# Alert Service Bulletin

## Alert Service Bulletin No. 085

### Heater Fuel Pump Leak Inspection and Replacement

**Figure 1 - Heater Fuel Pump Inspection Area**

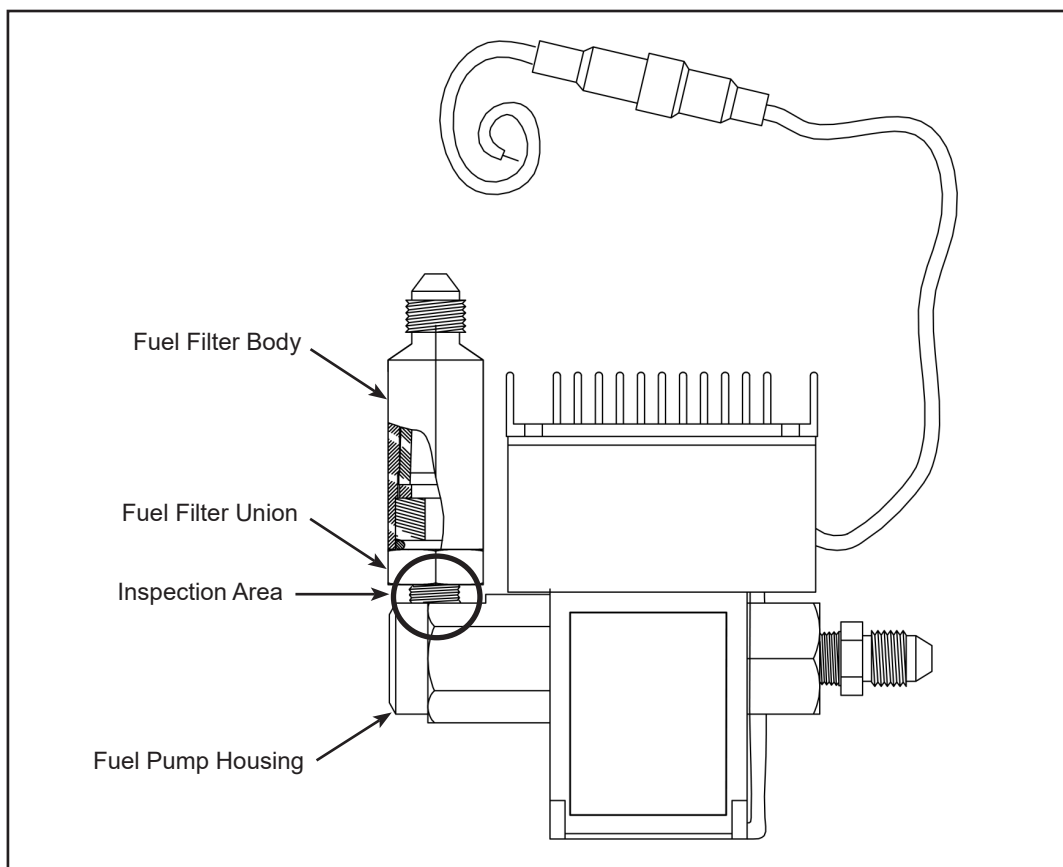
- (1) Fuel leakage from the fuel pump filter housing threaded connection to the fuel pump housing has been observed (see Figure 1).

- (1) Inspect the fuel pump and immediate area (Figure 1) for signs of leaking or blue fuel dye staining under the following conditions:
  - (a) Heater fuel pump de-energized;

- (1) Fuel Pump Replacement
  - (a) Replace the fuel pump with a unit not affected by this ASB in accordance with appropriate aircraft maintenance manual and airframe service instructions. Continue to 3.D.(1), Return to Service.
- (2) Heater System Deactivation
  - (a) Deactivate heater system in accordance with an approved minimum equipment list applicable to the aircraft until compliance with 3.C.(1) is completed.
